100 & 300 AREA UNIT MANAGER MEETING MINUTES

Groundwater and Source Operable Units; Facility Deactivation, Decontamination, Decommission, and Demolition (D4); Interim Safe Storage (ISS); Field Remediation (FR); and Mission Completion

December 8, 2011

Figure 1. Typical Design for Test Specimen 118D3-SSNF-018.

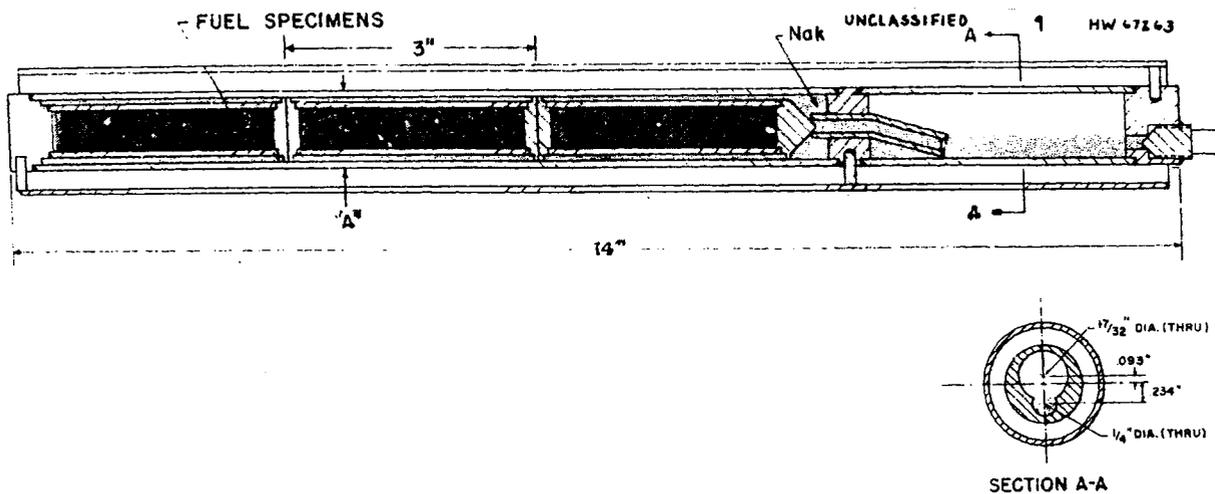
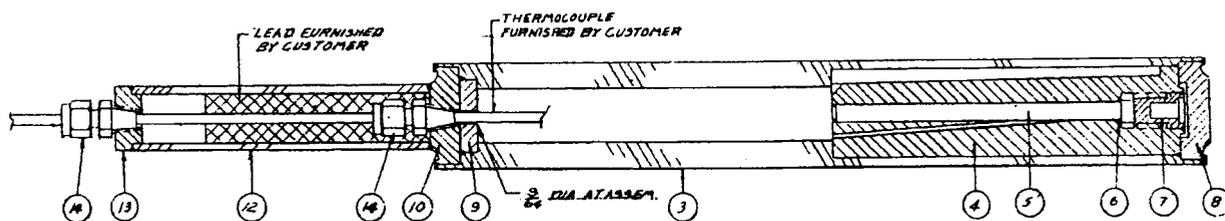
The Department of Ecology offers conditional acceptance of the Treatment Plan for 100-D Burial Grounds NaK based on compliance with ARARs described in Action Specific ARARs section 2.1.6.2 of the 100 Area RDRRAWP (DOE/RL-96-17 Rev. 6), specifically those described in WAC 173-303-140 Land Disposal Restriction. In addition DOH's has offered conditional acceptance of the Treatment Plan for 100-D Burial Grounds NaK based on compliance with ARARs described Chemical Specific ARARs section 2.1.6.1 of the 100 Area RDRRAWP (DOE/RL-96-17 Rev. 6), specifically those described in WAC 246-247 regulating radiation protection-air emission.

116-N-2, UPR-100-N-5 and UPR-100-N-25 Power Pole Agreement

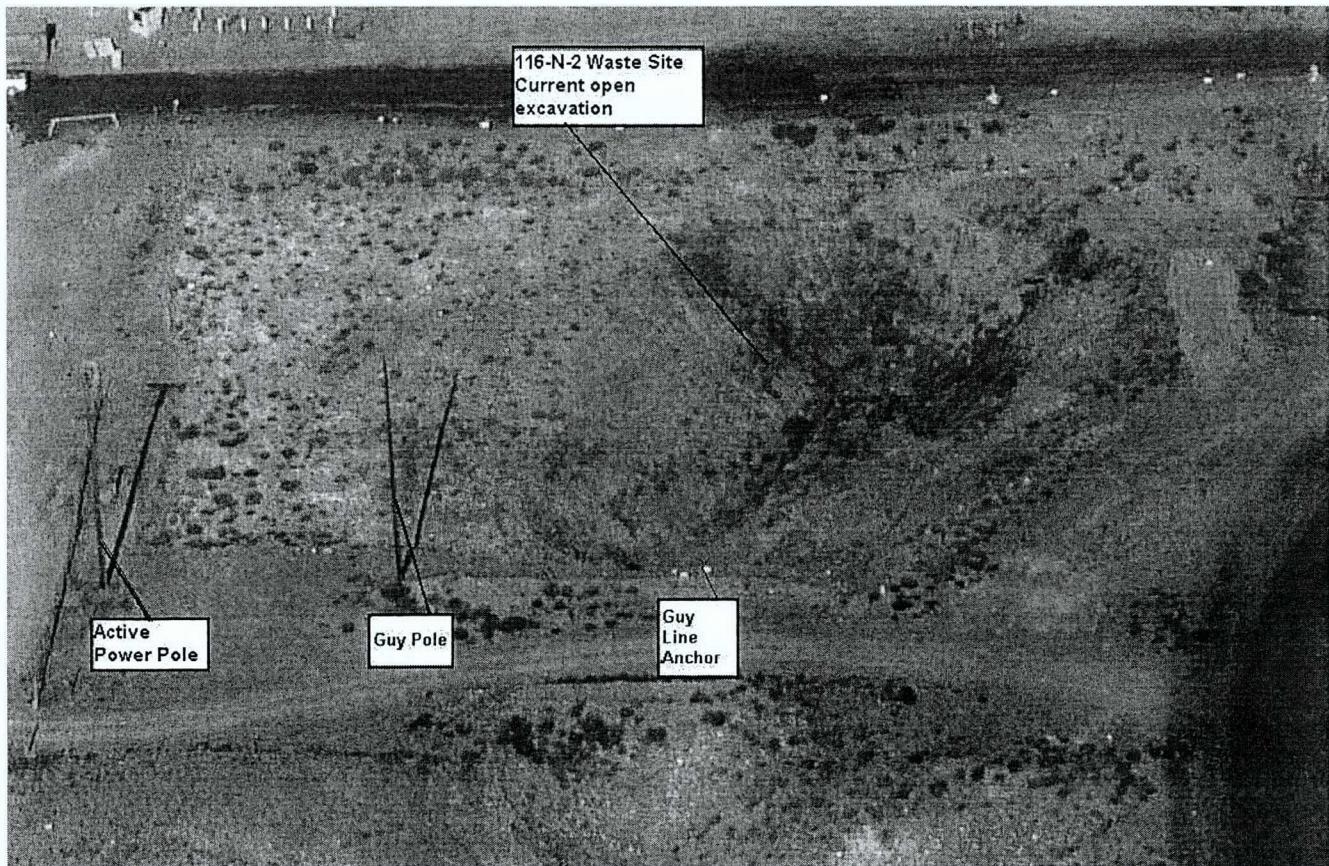
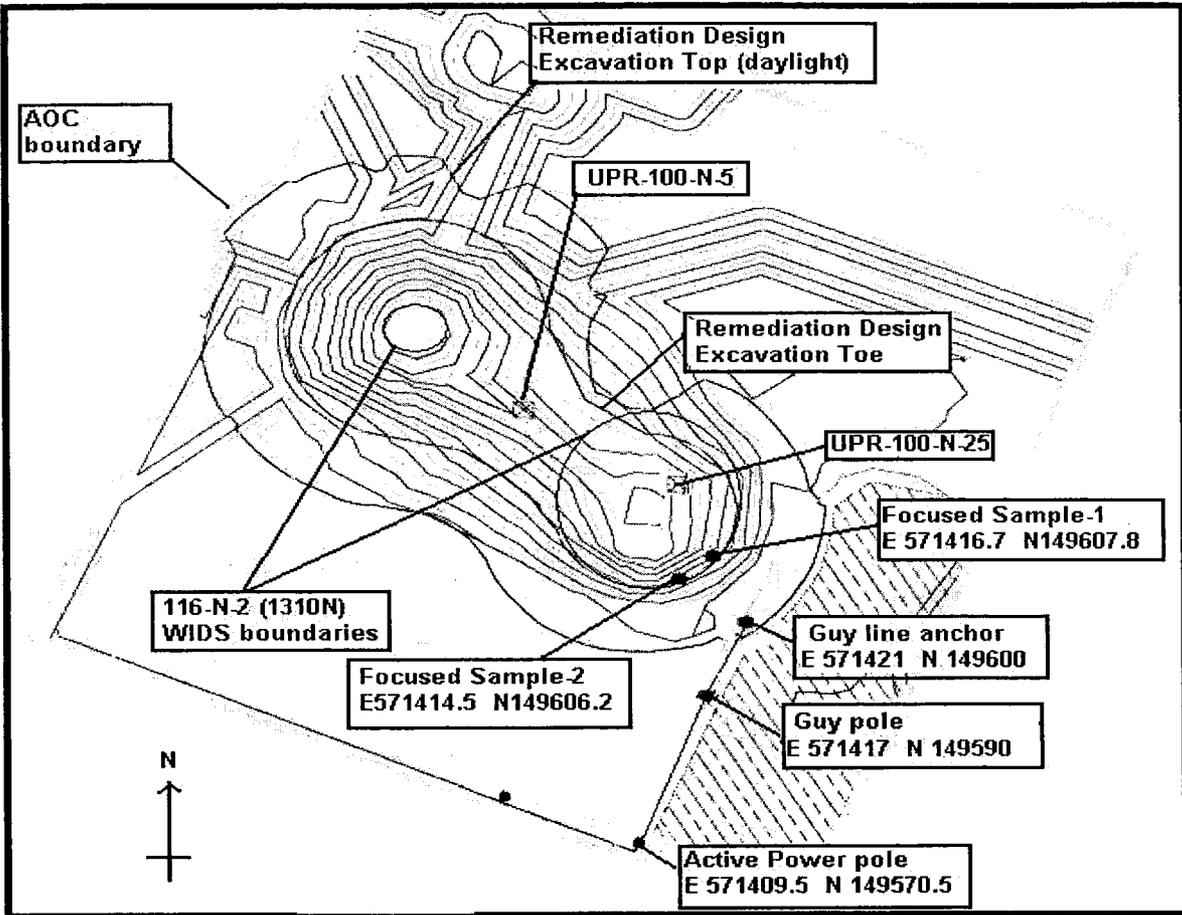
Field Remediation will potentially need to leave small amounts of soil in the southeast portion of the excavation for the 116-N-2 UPR-100-N-5 and UPR-100-N-25 due to potential impacts to the active power line poles at the edge of this site (see attached drawing and aerial photo).

This excavation was originally designed to maintain a 1.5:1 slope. We are proposing a 1:1 slope in this area to maintain the guy anchor lines for the pole. Taking any additional soil in this area could impact the integrity of the active power pole, guy pole, and guy line anchor. WCH would appreciate Ecology concurrence with the adjustment to the remediation design and the below agreement for verification sampling.

WCH will be including 2 focused samples under full protocol to support closeout in the waste site verification sampling in this area where soil will remain to show no contamination in this area. These focused samples will only be collected if a 1:1 slope is required. The location and coordinates of the focused samples is provided in the map below. Remediation activities will be guided by in-process sampling. If in-process samples indicate contamination above the direct exposure RAGs in this area, alternative stabilization of the active power line pole, guy pole and guy line anchor will be identified, and the area will be remediated as necessary. COPCs to be analyzed to support in-process sampling include cobalt-60, metals, anions, and volatile organic compounds, semivolatile organic compounds, and polynuclear aromatic hydrocarbons (PAH). The list of COPCs for verification sampling may be modified based on results of in-process sampling and will be provided in a verification work instruction of the waste sites for Ecology's approval. Information related to the above agreement will also be provided in the waste site specific verification work instruction and remaining sites verification package.

Focus sample locations have been added. Please provide concurrence.

Please provide a concurrence email and then next month Dan will present the agreement at the UMM.
